Re: Development Application D/2017/349 (SSD 8105)

My objections to this DA, as presented, are based on items from the Secretaries Environmental Assessment Requirements (SEAR) which are discussed below.

Attachment 1: From Elizabeth Street

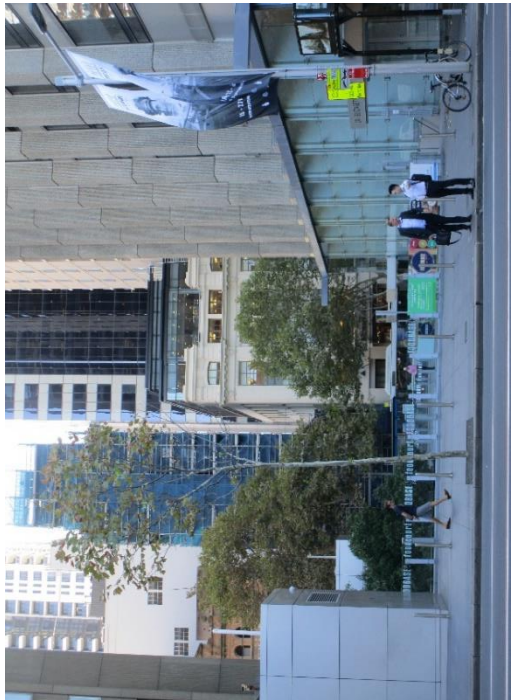
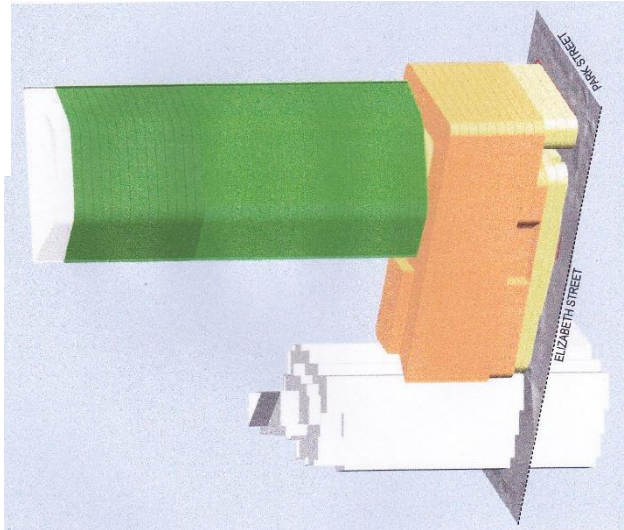
The openness of the corner of Elizabeth/Park/Castlereagh Streets will be gone as the predominantly one storey glass structure, which enables you to see the park from many angles, will be replaced by a solid, fourteen storey structure which uses the entire available space. Public space will be significantly decreased. Instead of the gentle opening up to the park, it will feel like walking up a chasm to reach Elizabeth Street with the park's importance being overshadow by the enormous bulk of the podium and the narrowness of the surrounding footpaths. See Attachment 1

Attachment 2: Change in Outlook

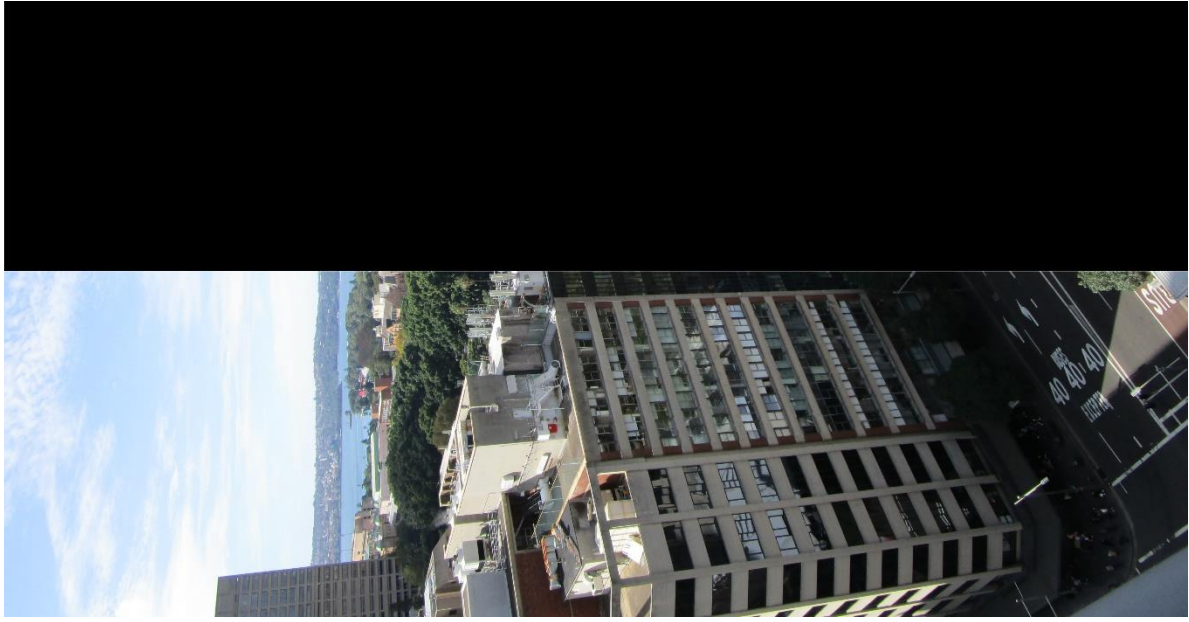
Design excellence is also lacking in some aspects of this development. Amenity will be lost for many surrounding residents. The outlook from my apartment is significantly reduced. I would think the loss would be approximately 70% by area. The DA shows the view extending as far as St Mary's Cathedral (Appendix D Design Report Part 5 Pgs. 66-67) but, as evidenced in Attachment 2, it goes down Sydney Harbour to the Heads. I expected to lose some amenity but not this much.
